Simplified & condensed information derived from 502-400-405 Issue 1 - 6-26-04 by S. Kerman

306A/C Desk Set & 356A/C Wall Set Modified for Individual Line Bridged Ringing.
(For 356 line connects directly to L1 & L2 without mounting cord.)

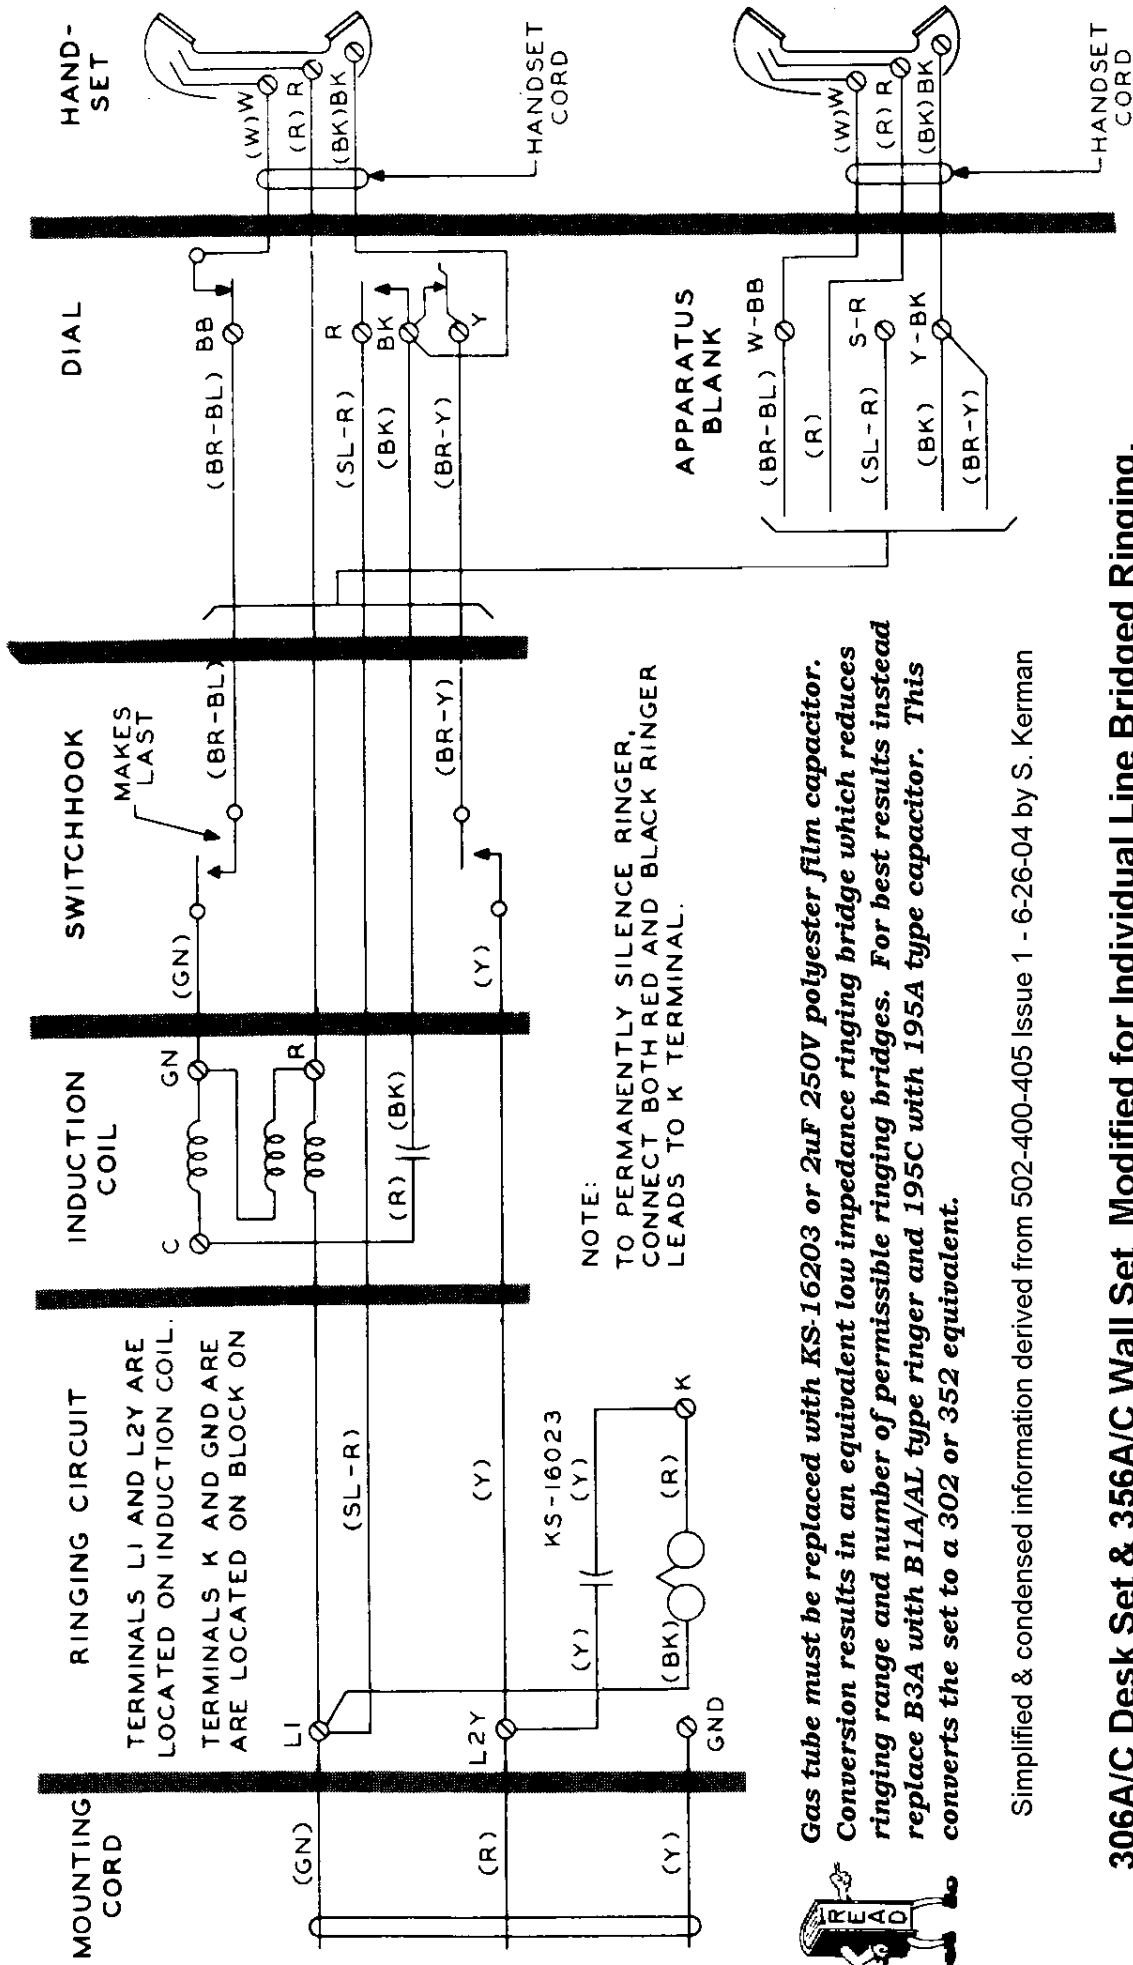
Gas tube must be replaced with KS-16203 or 2uF 250V polyester film capacitor. Conversion results in an equivalent low impedance ringing bridge which reduces ringing range and number of permissible ringing bridges. For best results instead replace B3A with B1A/AL type ringer and 195C with 195A type capacitor. This converts the set to a 302 or 352 equivalent.
